INDESIT company

BAAN33VPS

F034200

Notices

N1030093fig1

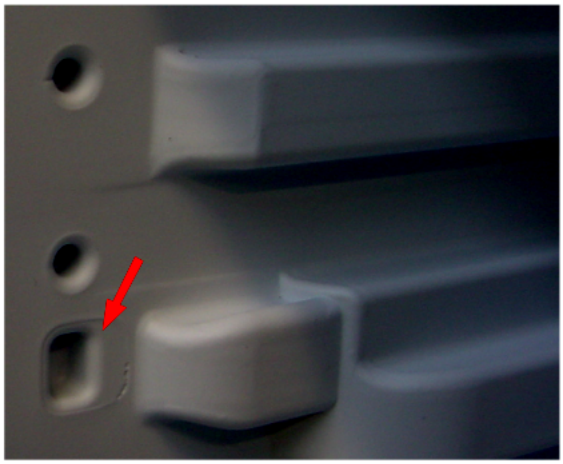
n1030093: New fixing of evaporator on static fridge-freezers (05 range) 60 cm,Melano

From August 05 (serial no. 50802.0001) the freezer evaporator is secured to the cabinet by a plastic profile.
The cabinet walls have been modified to create locations to house the profile, which is installed on the front of each evaporator plate (see photo N1030093fig1- fig2 - fig3)
The profile cannot be fitted on premodification appliances, so technical personnel must continue to fit the rh and lh supports on these models (see photo N1030093fig4)

New parts
C00141135 = WHITE PROFILE L=443.5 MM

Parts replaced
C00075596 = EVAPORATOR RH SUPPORT
C00075597 = EVAPORATOR LH SUPPORT

N1030093fig1

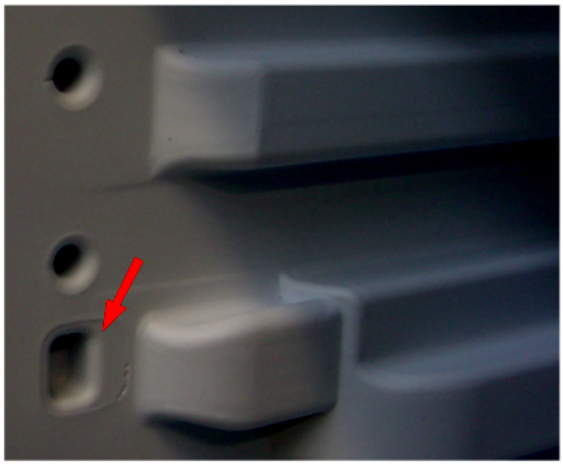
n1030094: New fixing of evaporator on static fridge-freezers (05 range) 60 cm, Lodowek

From August 05 (serial no. 50820.0001) the freezer evaporator is secured to the cabinet by a plastic profile.
The cabinet walls have been modified to create locations to house the profile, which is installed on the front of each evaporator

plate (see photo N1030093fig1- fig2 - fig3)
The profile cannot be fitted on premodification appliances, so technical personnel must continue to fit the rh and lh supports on these models (see photo N1030093fig4)

New parts
C00141135 = WHITE PROFILE L=443.5 MM

Parts replaced
C00075596 = EVAPORATOR RH SUPPORT
C00075597 = EVAPORATOR LH SUPPORT
